# Brookline Preservation Commission

## Local Historic District Report

**Local Historic District:** Lawrence

**Address:** 247-249 Kent Street

2 Second Floor Plan Detail Showing Fire Escape  
SCALE: 1/4" = 1'-0"

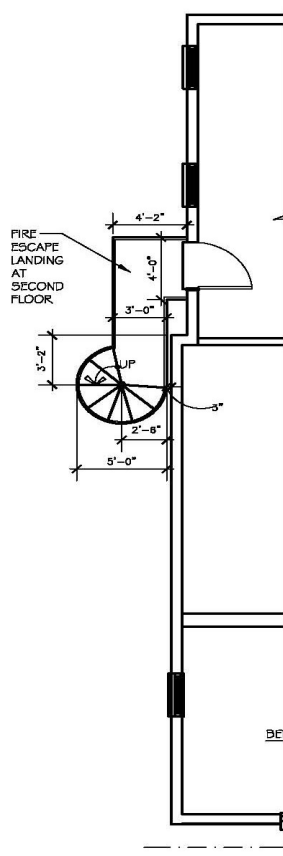
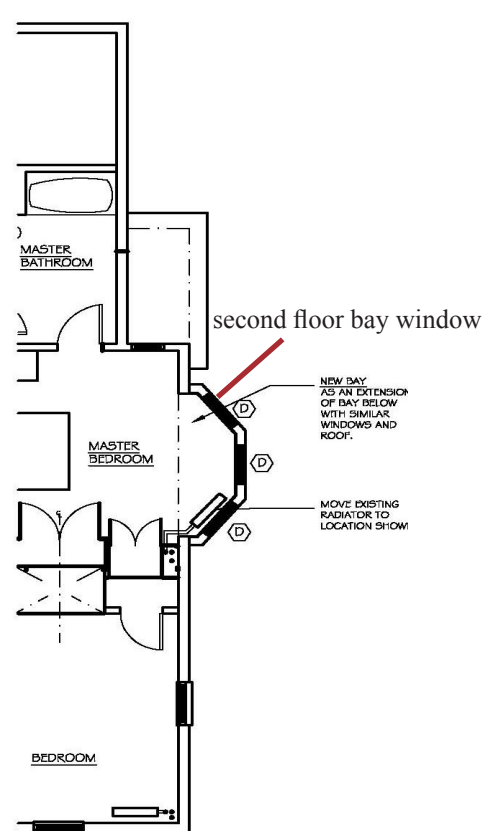
The applicant proposes to remove the existing fire escape and install a new spiral stair fire escape on the side, north elevation. Two first floor windows are proposed to be replaced with three windows to match others on house. The second floor window is proposed to be replaced with a door to meet egress and will match the pattern of the window fenestration. The third floor roof deck railing is proposed to be altered to meet code. The existing wood steps and landing on the north elevation entry are proposed to be replaced and a new shed roof canopy will be installed using historic brackets that were found in the building's basement. Lastly proposed is to extend existing bay window to the second floor on the south elevation. All windows for the project are to be single pane, true divided light.

Proposed Kent Street facing West elevation

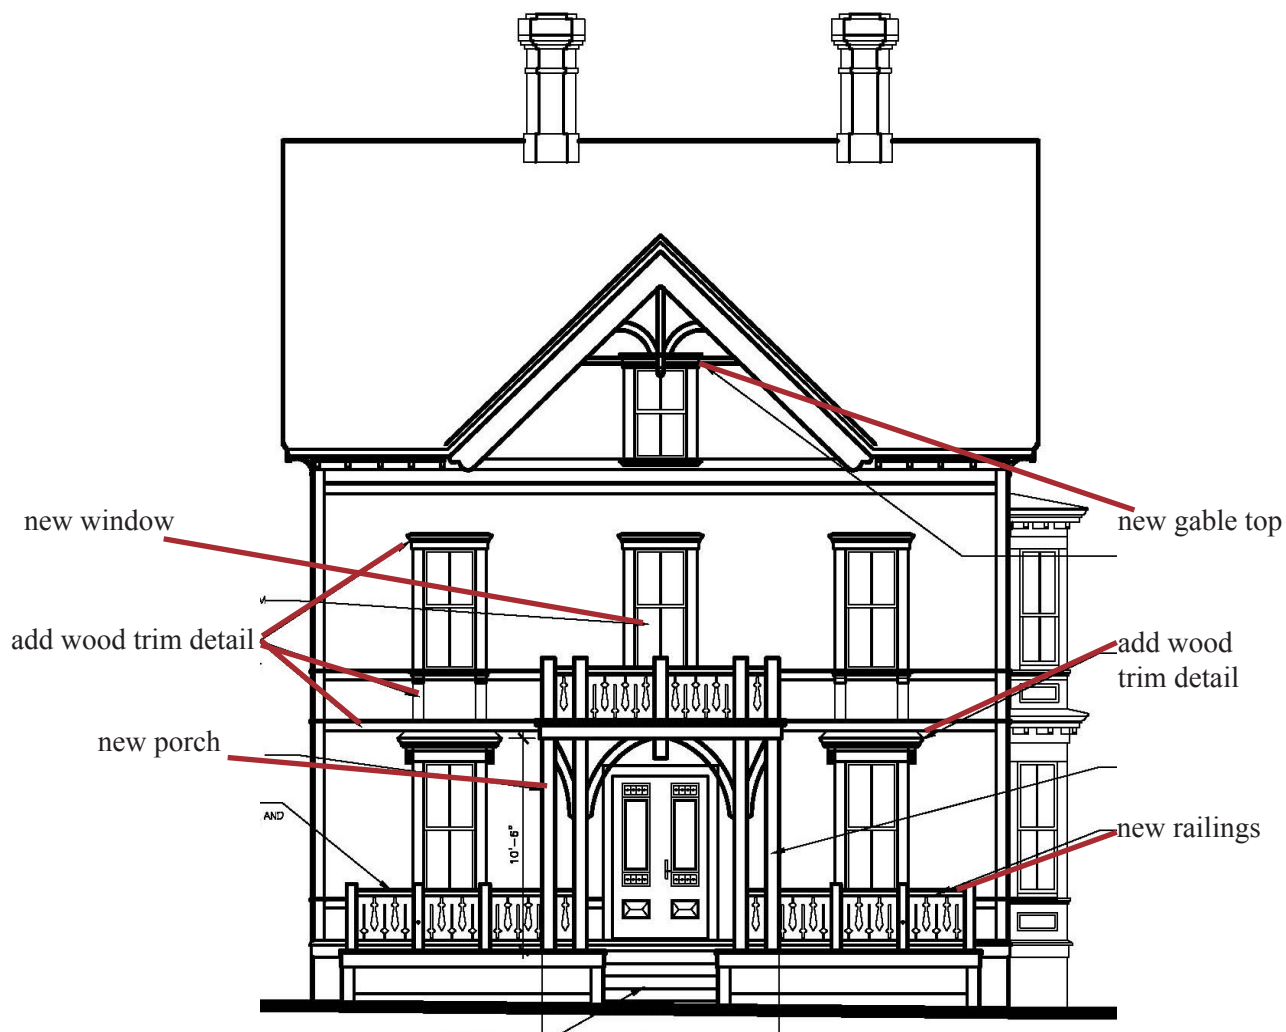
**Proposed Alterations:** The applicant proposes to replace the existing front porch deck railing and remove the pitched roof entrance canopy on the west elevation. A 12' 5" by 6' 10" new roofed entrance porch is proposed to replace the existing canopy, which was a later addition to the building. A historic photograph shows a full porch was once present, as well as a second floor oriel window above the porch. A new second floor window, with decorative trim, is proposed to replace a non-historic window for the west, Kent Street facing elevation. The window will match the others, in fenestration pattern and operation, on the elevation. Although the above porch alteration is preferred, the applicant has provided two alternative options for the porch design. Option 2 includes a pitched roof similar to the existing and the same second floor window change. Option 3 is the closest in design (however, not the full length porch) to the historic image of the porch which includes the reintroduction of the second floor oriel window. The reestablishment of a historic gable top detail, which can be seen in the historic photo, is also proposed for the west elevation.

**Preliminary Findings:** The replacement of the fire escape and deck railing on the north elevation appear to be in compliance with the Design Guidelines for Local Historic Districts and are reversible. The preferred option of the west elevation porch alteration and window is not in compliance with the Local Historic District Guidelines since there is photographic evidence of what the porch once looked like. The guidelines state that when reintroducing historic features there should be proof of what was once there. The Commission should analyze closely what the appropriate treatment may be for the front porch as well as the extension of the south elevation bay to the second floor.
